# UNITED STATES PATENT AND TRADEMARK OFFICE

APPLICATION NO.	FILING DATE	FIRST NAMED INVENTOR	ATTORNEY DOCKET NO.	CONFIRMATION NO.
10/723,588	11/26/2003	Adrian B. Chernoff	GP-303033	7594

<b>Office Action Summary</b>	Application No. 10/723,588	Applicant(s) CHERNOFF ET AL	
	Examiner Joseph F. Edell	Art Unit 3636

## DETAILED ACTION

Diagram A - Annotated Figure 1 of Semplonius et al.

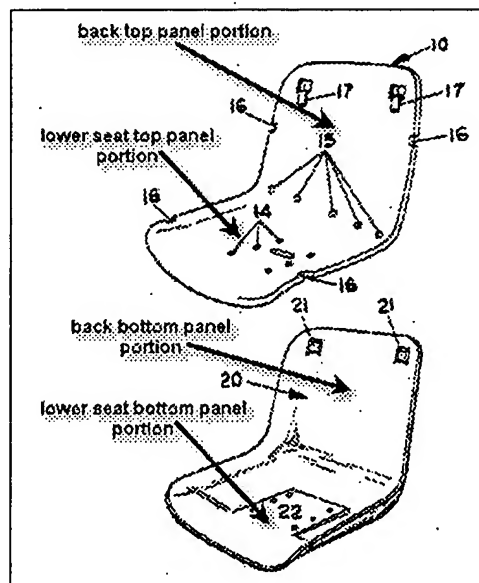
Semplonius et al. disclose a seat that appears to teach all the limitations recited in claims 1, 2, 4, 13, and 16. Semplonius et al. show a seat having a seat frame of a top panel portion 10 (see Fig. 1) and a bottom panel portion 20 with a surface juxtaposed with a surface of the top panel portion, a lower seat portion of the panel portions, and a back portion of the panel portions wherein the lower seat portion has top and bottom panel portions, the back portion has top and bottom panel portions, the top

panel and bottom panel portions are each unitary, one-piece panels, the lower seat portion has a lower seat bottom panel portion and a matable lower seat top panel portion, the back portion has a back bottom panel portion and a matable back top panel portion, one of the lower seat portion and the back portion is adapted to receive a seat cushion 40 (Fig. 6), the back portion is formed with an integral flange 17 (Fig. 8), and the integral flange is connectable with respect to the other of the back portion to partially join together. See Diagram A identifying the panel portions of the seat taught by Semplonius et al. Semplonius et al. teaches a seat that appears to be the same as, or an obvious variant of, the seat set forth in the product-by-process claim 1 although produced by a different process.

7. Applicant's arguments filed 16 May 2005 have been fully considered but they are not persuasive. Applicant argues that Semplonius et al. fails to teach a bottom panel portion that has a surface that is substantially juxtaposed with a surface of the top panel portion, as recited in amended claim 1. However, Figure 8 of Semplonius et al. shows a surface of the back top panel portion juxtaposed with a surface of the back bottom panel portion via the mating interconnection of the flange 18 of the back top panel portion with the well 21 of the back bottom panel portion. Next, Applicant argues that Dystra et al. fails to teach a bottom panel portion with a surface substantially juxtaposed with a surface of a top panel portion. Examiner reasonably interprets juxtaposed as being adjacent, as defined in *Merriam-Webster's Collegiate Dictionary, Tenth Edition*. Figure 7 of Dystra et al. shows that the lower seat bottom panel portion is adjacent to the lower seat top panel portion and the back portion bottom panel portion is adjacent to the back portion top panel portion. Therefore, Dystra et al. teach a vehicle seat with a top panel portion and a bottom panel portion with a surface substantially juxtaposed with a surface of the top panel portion. Next, Applicant argues that Dystra et al. fail to teach a corrugated panel portion. See the above rejection for motivation to combine the teachings of Dystra et al. in view of Rossman. Lastly, Applicant argues that the combination of Dystra et al. in view of Vishey et al. is improper because there is no
